13223
17 May 2013

**SUBMISSION - NORTH WEST RAIL LINK CORRIDOR STRATEGY
139- 145 CASTLE HILL ROAD, WEST PENNANT HILLS**

JBA Planning (JBA) has prepared this submission on behalf of various land owners in response to the NSW Government's recently exhibited *Draft North West Rail Link Corridor Strategy* (herein referred to as the **draft Strategy**) and the accompanying *Cherrybrook Station - Draft Structure Plan* (herein referred to as **Cherrybrook Structure Plan**).

Figure 2-1 – Cherrybrook Structure Plan and the subject sites

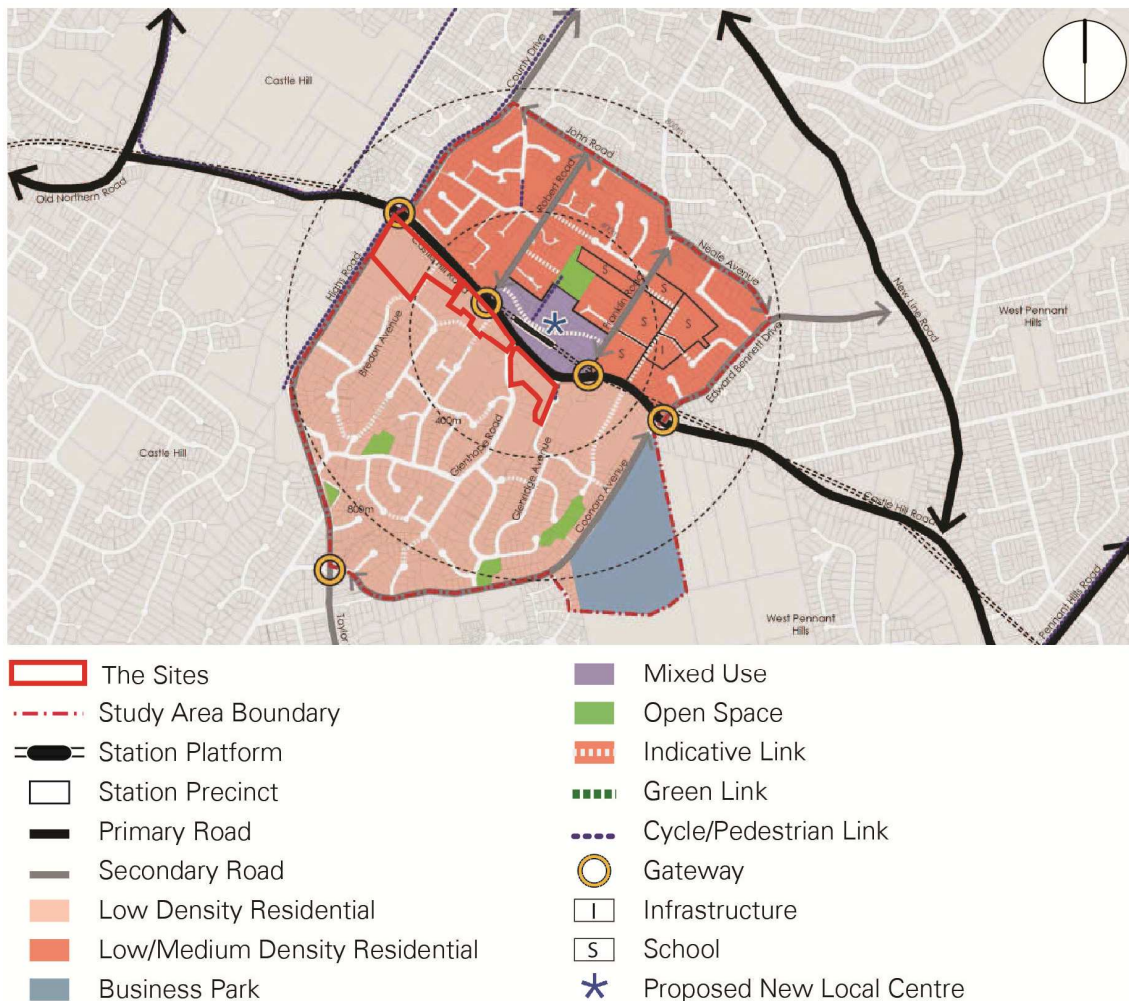
The land owners support the intent of the draft Strategy and Cherrybrook Structure Plan. However the draft Structure Plan ignores the potential for surrounding land in West Pennant Hills to accommodate any new and significant residential accommodation in the close proximity to the future station at Cherrybrook.

- Although well within the 800m walkable catchment of the future Cherrybrook Station, all such land south of Castle Hill Road has been considered incapable of accommodating any further or significant residential development.

- as being within 400-600m radius of the future train station for Cherrybrook;
- as containing significant stands of Blue Gum Forest;
- as being affected by landslip conditions; and
- as retaining current zoning and planning regimes that reinforce very low residential development outcomes.

On the basis of the above, it is requested the draft Cherrybrook Structure Plan be revised to identify capability for medium to high density residential development over the land that is referred to in Section 3.0 of this submission.

Figure 3-1 – Landslip map from The Hills LEP 2012 and the subject sites

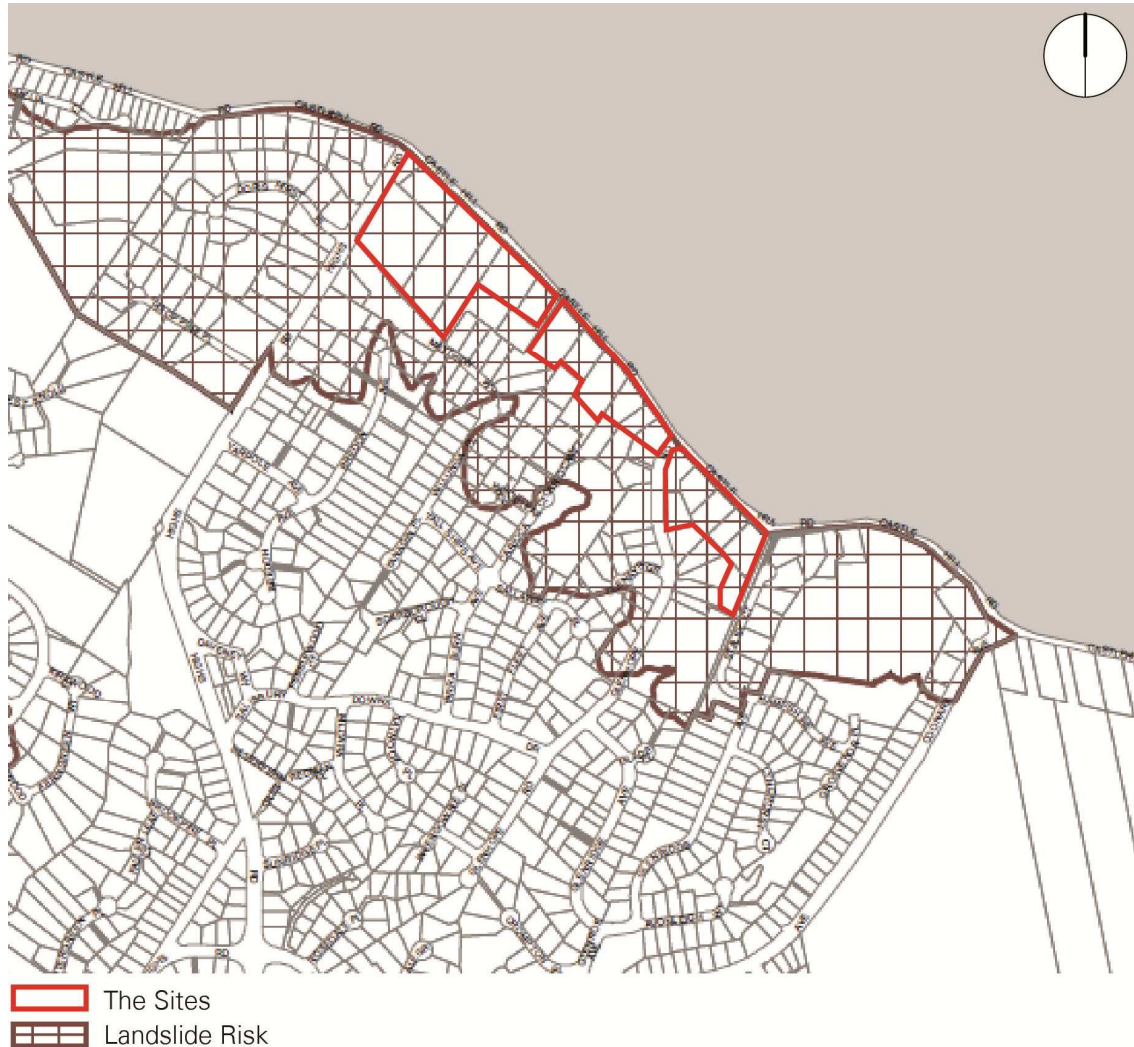
Under clause 7.6 of The Hills LEP 2012 the sites are all identified as 'landslip risk' (see **Figure 3-1**). The objective of this clause is to “ensure that development is commensurate to the underlying geotechnical conditions and to restrict development on unsuitable land.” Under Council’s DCP part of the site is identified as ‘restricted development’, which relates to a small riparian corridor.

It is understood that this E4 Living zone has been applied to the sites given this land is at risk of landslip. However, this is based upon the Soil Conservation Service of NSW (SCS) Urban Capability Study (UCS) which was prepared in 1977. This out-dated report continues to the principal document that Council has relied upon to this retain the landslip risk classification over the subject and adjoining sites directly south of Castle Hill Road.

Despite this disclaimer the Council has insisted upon relying on this out-dated report to then retain the sites' landslide risk classification and restrict development to very low density residential development, much of which has resulted and encouraged the development of larger scale dwellings that could rival the scale of small residential flat buildings.

To facilitate medium and high density residential outcomes over the site we strongly recommend that DPI undertake a review of The Hills DCP geotechnical and development controls to ensure the Council's requirements do not impede medium density housing and apartment construction in the NWRL Corridor and to bring these controls in alignment with current best practice (see more detail at **Attachment A**).

Figure 3-2 – Figure from Council Meeting Report dated 14 May and the sites that are subject of this submission

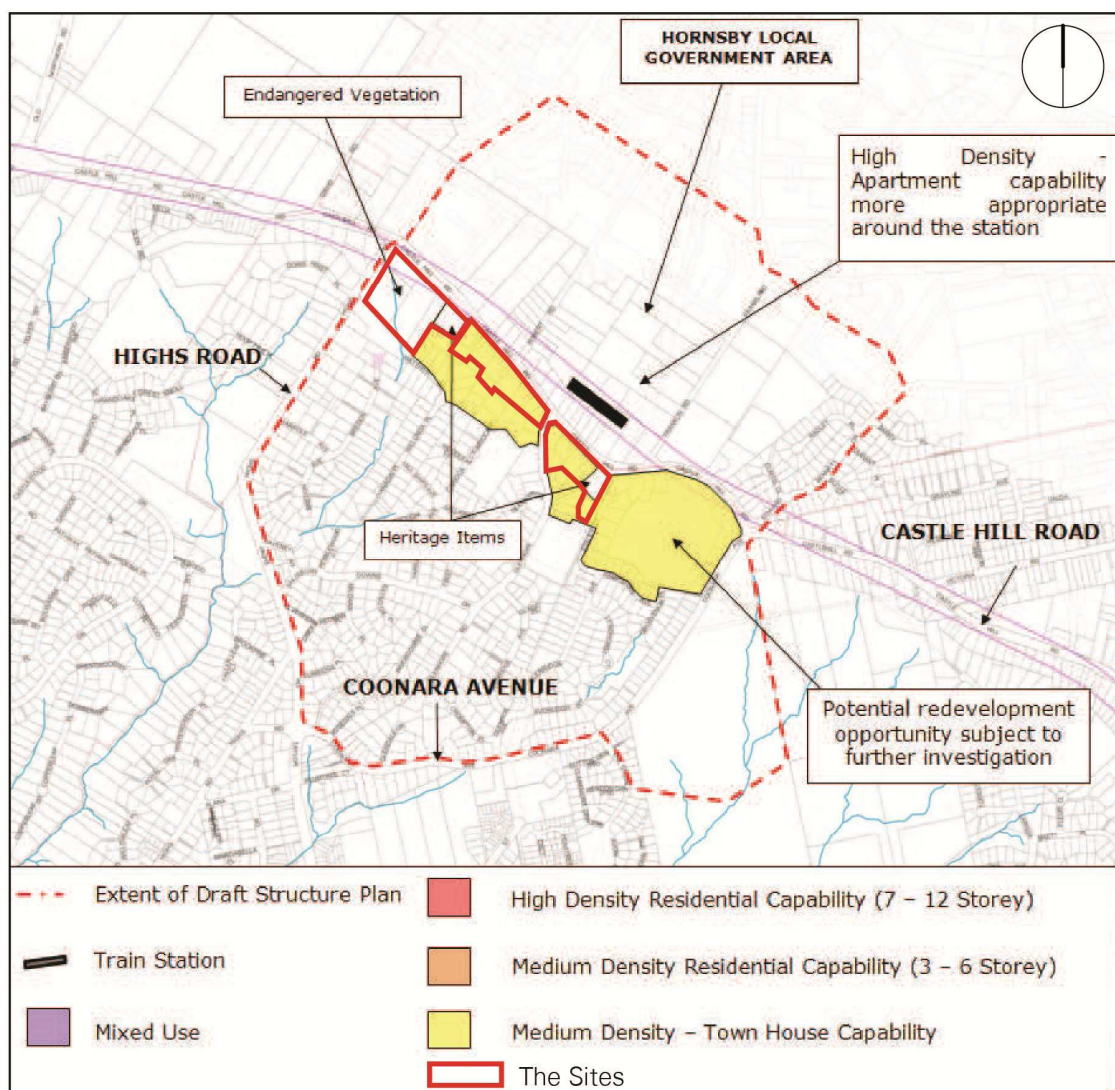
On review of Council's report at its 14 May 2013 meeting, Council has recognised that landslide should not preclude the opportunity for increased residential density on land identified as landslide (see **Attachment B – Council's Report**), albeit it only recommends medium density residential development potential. However, it is unclear why Council's report recommends that the some subject sites be excluded from being afforded the same residential development potential as these are similarly affected and characterised sites (see **Figure 3-2**).

Although the Council has recommended that some medium density development (being only town houses) should be achieved over some of the land south of Castle Hill Road (see **Figure 3-2**), the logic for which these lands were selected and not other land is unclear. For instance, much of the land within the walkable catchment and in West Pennant Hills continues to be precluded from the opportunity to deliver alternative and increase density forms of housing, even though much of this land is unconstrained. Moreover, it unclear why more other forms of residential development have been overlooked for the remainder of West Pennant Hills as this type of development would ensure efficient use of land in the vicinity of the NWRL and deliver significantly more opportunities for residential accommodation in the shorter term to then realise the vision for the NWRL

On this basis the subject sites referred to in this submission and other sites with similar characteristics like these in West Pennant Hills should be identified for potential medium to high density residential development to then assist in utilising the station and providing opportunities for housing in good proximity to well connected public transport.
